566 COLUMBUS AVE., BOSTON SOUTH END LANDMARK DISTRICT COMMISSION

18 MAY 2020

DESIGN REFINEMENTS BASED ON LANDMARKS AND BDPA JOINT DESIGN REVIEWS AND COMMUNITY INPUT:

BEFORE
(JAN 7, 2020 LANDMARKS DESIGN REVIEW)

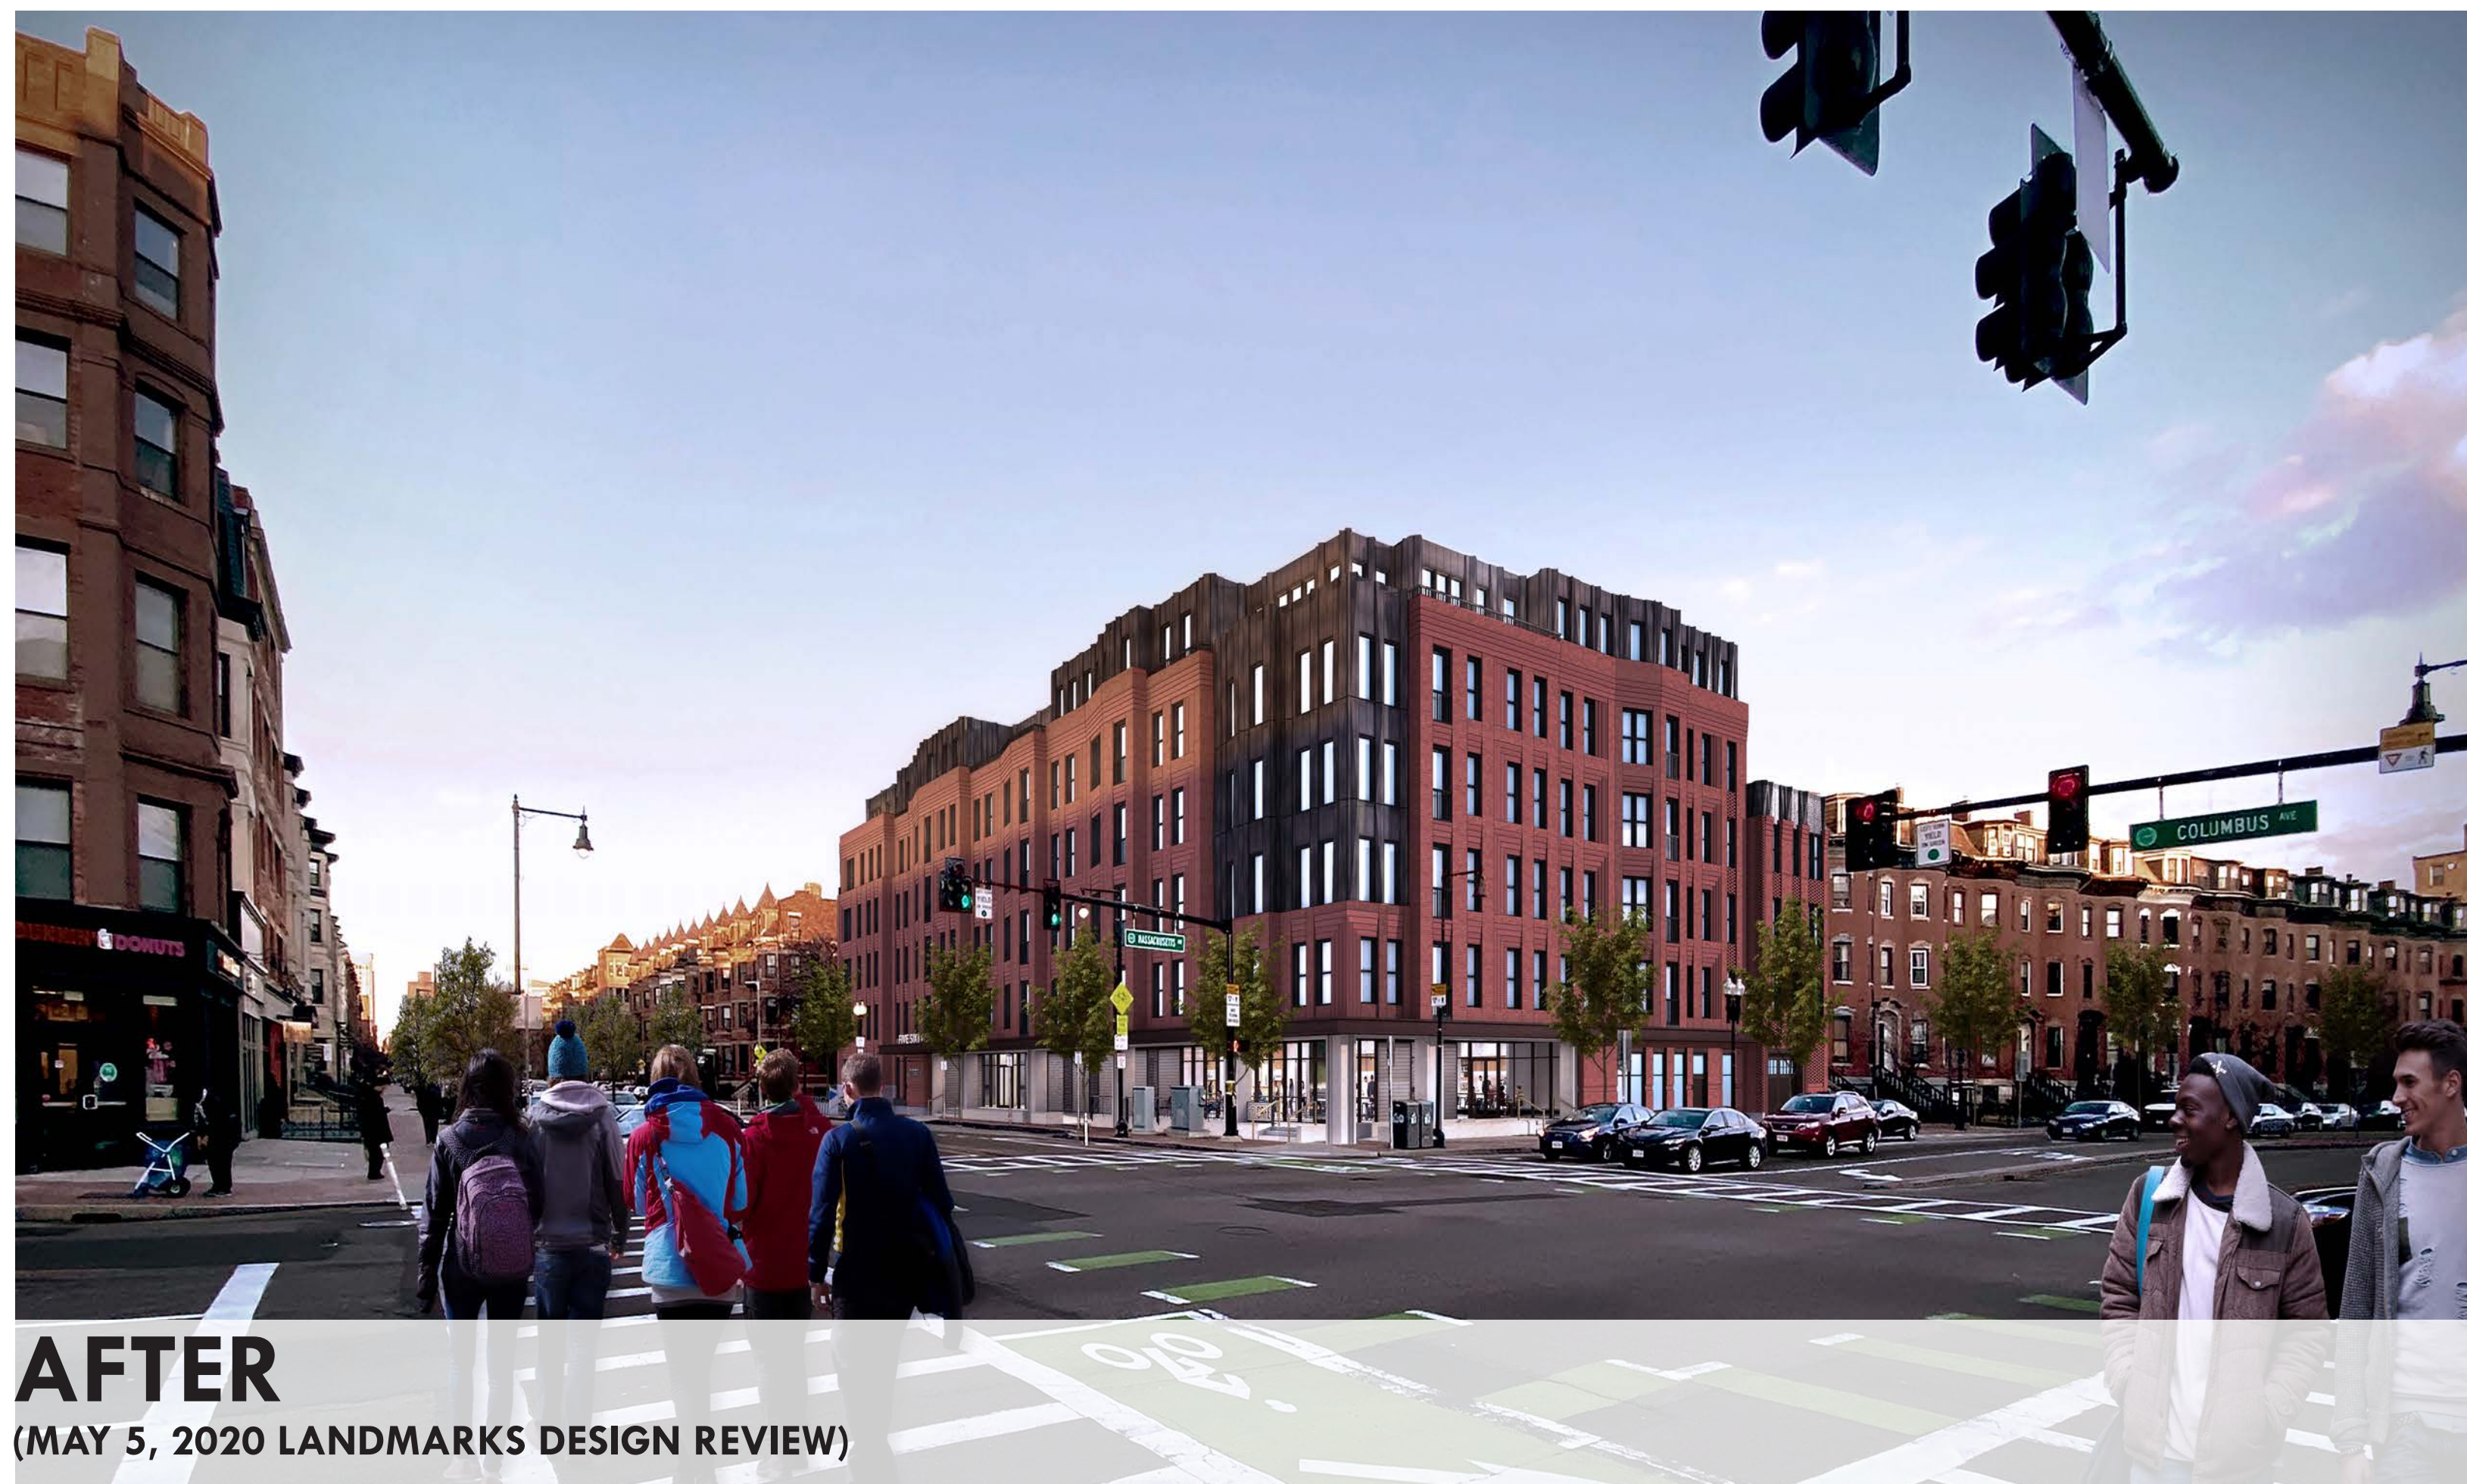
- Picket railings appear more exposed at attic story
- Two-story / one-story metal datum conflicts continuous cornice line
- Two-tone fiber cement cladding material requires further study for District compatibility
- Metal cladding between windows appears inconsistent
- Juliet balconies extend beyond the building facade with randomized arrangement
- Metal clad detailing and proportions require further study and careful articulation
- Window types appear monolithic and inconsistent with the District. Openings, require further study and careful articulation
- Ground level entry conditions, delineation of commercial vs. residential, materiality and integration with public realm/streetscape all require further study

- Steel picket rail heights are substantially reduced and are consistent with the Architecture of the District
- Corbelled brick cornice establishes a consistent datum, creates a clear delineation between brick and metal cladding, and subdivides the massing into "townhouse-like" proportions consistent with the Architecture of the District

- Anodized dark-bronze metal cladding defines the prominence of the corner and is carefully detailed with a nod toward the sense of depth, shadow, and sculpted "folds" and "pleats" consistent with the Architecture of the District

- Steel picket rails are captured within masonry openings and designed to be consistent with the Architecture of the District
- Red brick masonry cladding, detailing and articulation is designed to be consistent with the Architecture of the District

- Aluminum clad double-hung windows are designed to be consistent with the Architecture of the District, in color, frame profile and proportion
- Expressed steel beam detail establishes a strong base-to-middle transition, and defines and unifies the canopy/soffit entry conditions consistent with the Architecture of the District

- Natural stone column enclosures create a steady rhythm along the streetscape and frame openings for entry and public realm gathering consistent with the Architecture of the District
